MODEL: <b>J &amp; D Series</b>	TYPE: <b>Field Change Program</b>	SECTION/GROUP: <b>03- Body</b>	DATE:
-----------------------------------	--------------------------------------	-----------------------------------	-------

Ref. MCI NHTSA Recall No.: 19V-344  
Specialty Manufacturing, Inc. NHTSA Recall No.: 19E-017

Ref. MCI Transport Canada Recall No.: 2019-214

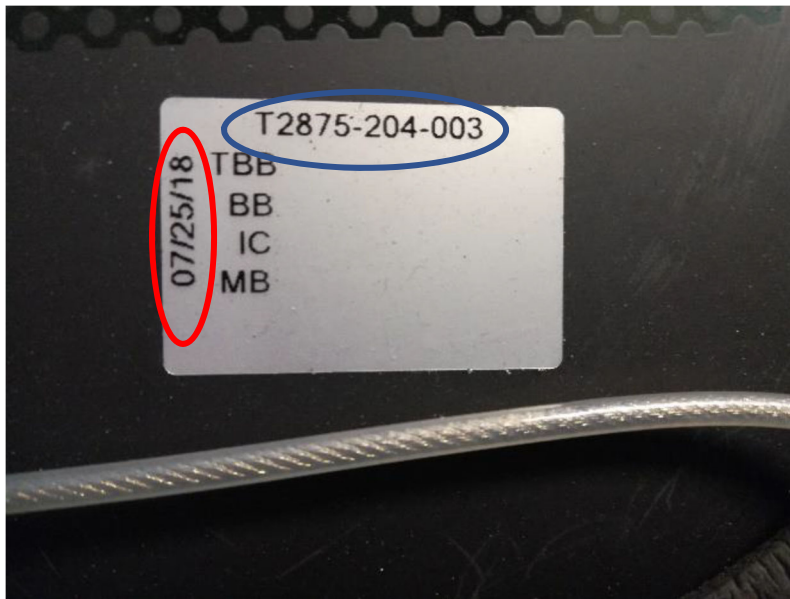
Check the label on the bottom of the Transpec Glass Hatch p/n T28XX-XXX-XXX (circled below in blue) for dates between August 1, 2018 and February 22, 2019 (circled below in red). Units built within this date range are subject to the replacement campaign.
